ATTACHMENT C

LIST OF AFFECTED TECHNICAL SPECIFICATION PAGES

ATTACHMENT D

PROPOSED TECHNICAL SPECIFICATION CHANGES

Figure 3.2.1-3

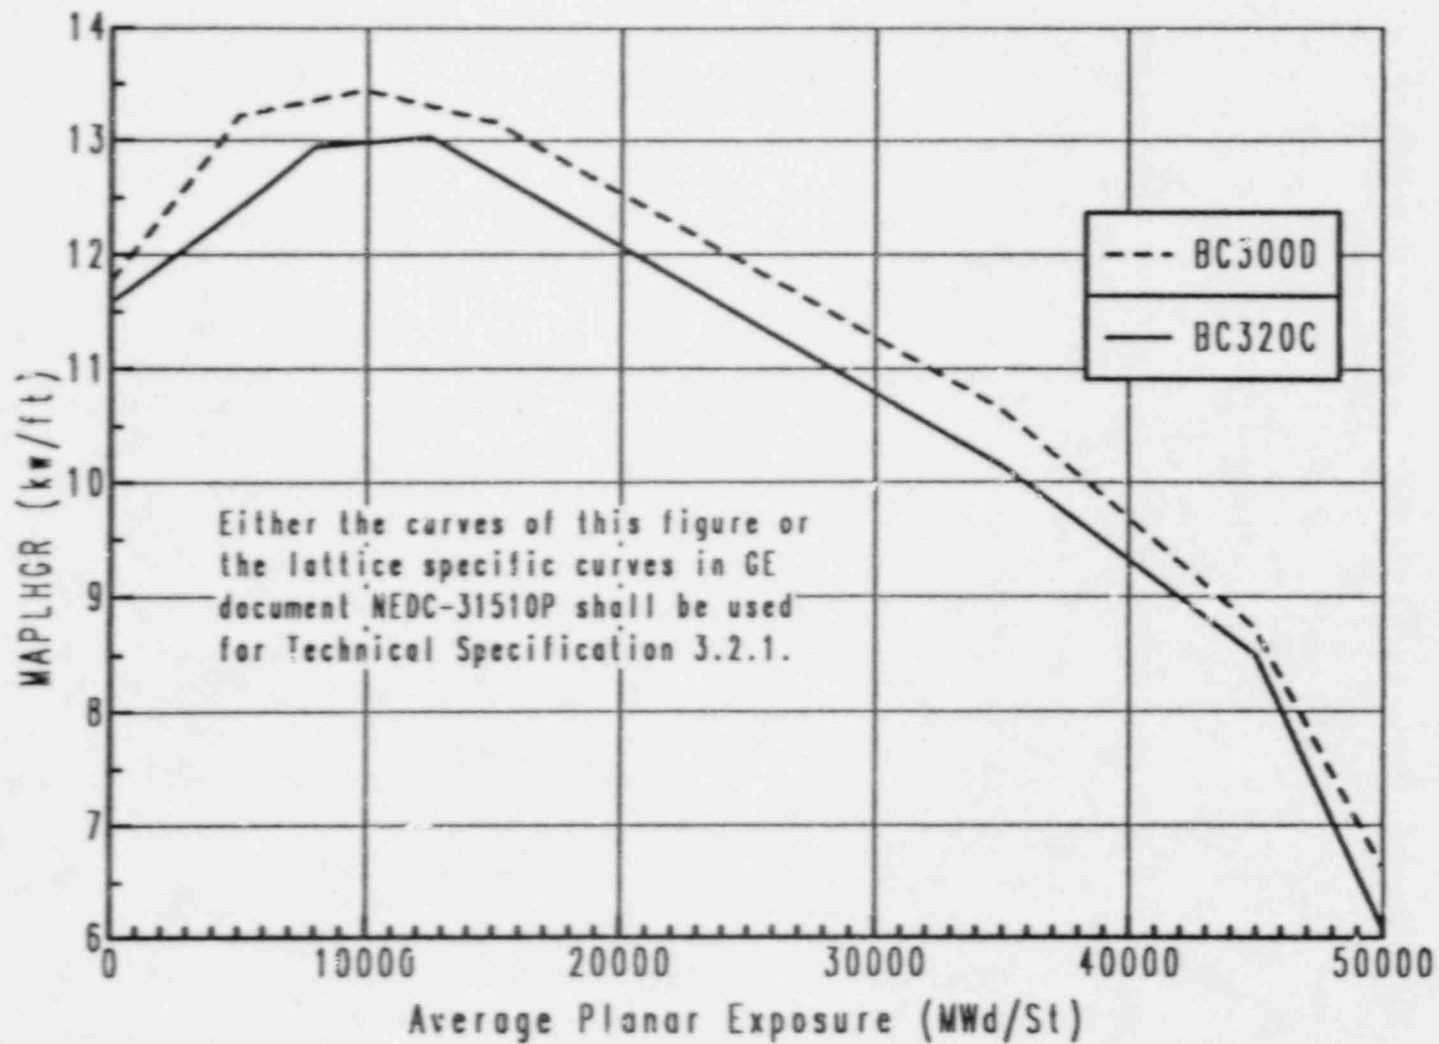
3.2.1 All AVERAGE PLANAR LINEAR HEAT GENERATION RATES (APLHGRs) for each type of fuel as a function of AVERAGE PLANAR EXPOSURE shall not exceed the limits shown in Figures 3.2.1-1, and 3.2.1-2, <sup>and 3.2.1-3</sup> ~~The limits of Figures 3.2.1-1 and 3.2.1-2 shall be reduced to a value of 0.85 times the two recirculation loop operation limit when in single recirculation loop operation.~~

With an APLHGR exceeding the limits of Figures 3.2.1-1, <sup>and 3.2.1-3</sup> ~~and 3.2.1-2~~, initiate corrective action within 15 minutes and restore APLHGR to within the required limits within 2 hours or reduce THERMAL POWER to less than 25% of RATED THERMAL POWER within the next 4 hours.

4.2.1 All APLHGRs shall be verified to be equal to or less than the limits determined from Figures 3.2.1-1, ~~and 3.2.1-2~~, <sup>and 3.2.1-3</sup>:

The APIHGR values for the reload fuel shown in Figure 3.2.1-3 are based on the fuel thermal-mechanical design analysis. The improved SAFER/GESTR-LOCA analysis (Reference 3) performed for Cycle 3 used bounding MAPLHGR values of 13.0 and 14.0 kw/ft, independent of nodal exposure. These MAPLHGR values are higher than the expected "thermal-mechanical MAPLHGR" for both BPSX8R and GESX8EB fuel. Therefore, SAFER/GESTR established that for all BPSX8R and GESX8EB fuel designs the MAPLHGR values are not expected to be limited by LOCA/ECCS considerations. However, MAPLHGR values are still required to assure that the LHGR limits are not compromised and, consequently, fuel rod mechanical integrity is maintained.

Figure 3.2.3-1 MINIMUM CRITICAL POWER RATIO (MCPR) VERSUS  $\tau$  AT RATED FLOW

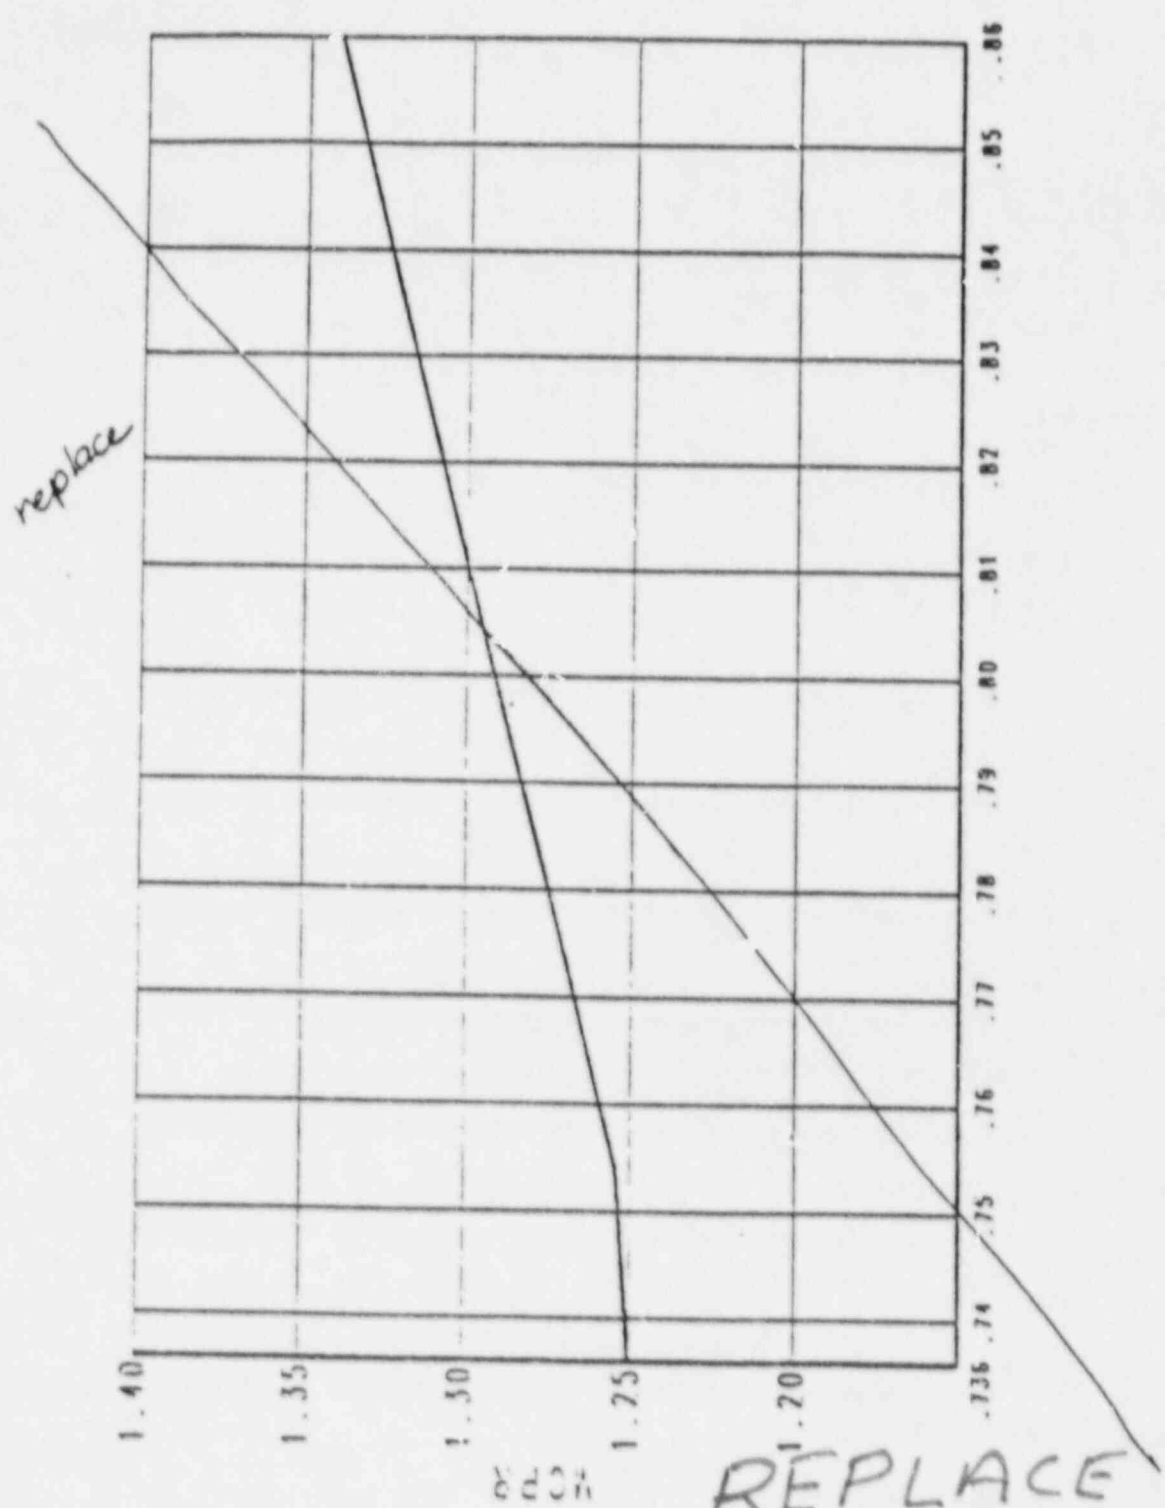
~~3.2.3 The MINIMUM CRITICAL POWER RATIO (MCPR) shall be equal to or greater than the MCPR limit determined from Figure 3.2.3-1 times the  $K_T$  determined from Figure 3.2.3-2 for two recirculation loop operation and shall be equal to or greater than the MCPR limit determined from Figure 3.2.3-1 + 0.01 times the  $K_T$  determined from Figure 3.2.3-2 for single recirculation loop operation.~~

REPLACE WITH NEW PAGE

3.2.3 - The MINIMUM CRITICAL POWER RATIO (MCPR) shall be equal to or greater than the MCPR limit determined from:

- a. Single Recirculation Loop Operation  
Figure 3.2.3-1a (Curve A for a RBM setpoint of 106% or Curve B for a RBM setpoint of 110%) plus 0.01, times the  $K_{\text{eff}}$  determined from Figure 3.2.3-2.

- b. Two Recirculation Loop Operation  
Figure 3.2.3-1a (Curve A for a RBM setpoint of 106% or Curve B for a RBM setpoint of 110%) times the  $K_{\text{eff}}$  determined from Figure 3.2.3-2.

Figure 3.2.3-1b

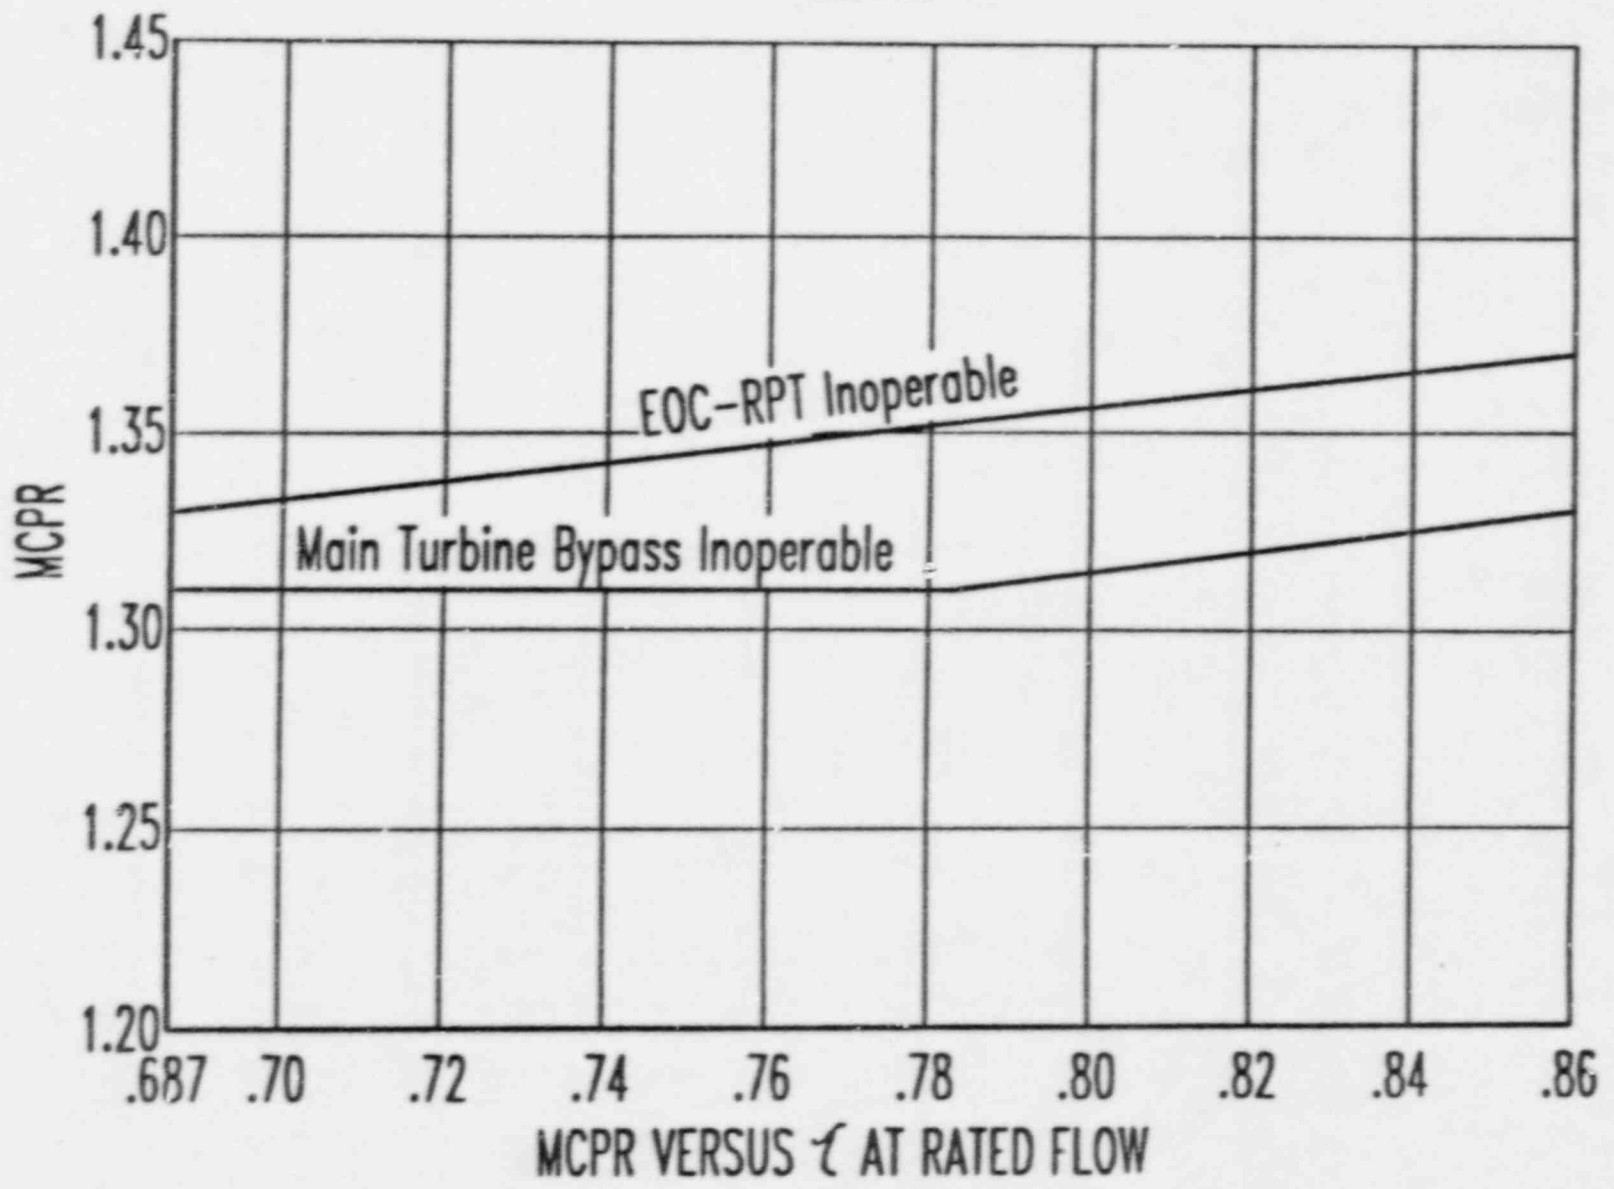
- c. Two Recirculation Loop Operation with Main Turbine Bypass Inoperable  
Figure 3.2.3-1b times the  $K_{\text{eff}}$  determined from Figure 3.2.3-2, for two recirculation loop operation, with the main turbine bypass system inoperable per Specification 3.7.10 (any RBM setpoint determined per Specification Table 3.3.6-2 may be used).

- d. Two Recirculation Loop Operation with End-of-Cycle Recirculation Pump Trip System Inoperable  
Figure 3.2.3-1b times the  $K_{\text{eff}}$  determined from Figure 3.2.3-2, for two recirculation loop operation, with the end-of-cycle recirculation pump trip system inoperable as directed by Specification 3.3.4.2 (any RBM setpoint determined per Specification Table 3.3.6-2 may be used).

For the main turbine bypass and recirculation pump trip systems, specific cycle-independent MINIMUM CRITICAL POWER RATIO (MCPR) Limiting Condition for Operation (LCO) values are established to allow continuous plant operation with these systems out of service. A bounding end-of-cycle exposure condition was used to develop nuclear input to the transient analysis model. The bounding exposure condition assumes a more top-peaked axial power distribution than the nominal power shape, thus yielding a bounding scram response with reasonable conservatism for the MCPR LCO values in future cycles. The cycle independent MCPR LCO values shown in Figure 3.2.3-1 for the main turbine bypass and recirculation pump trip systems out of service are valid provided:
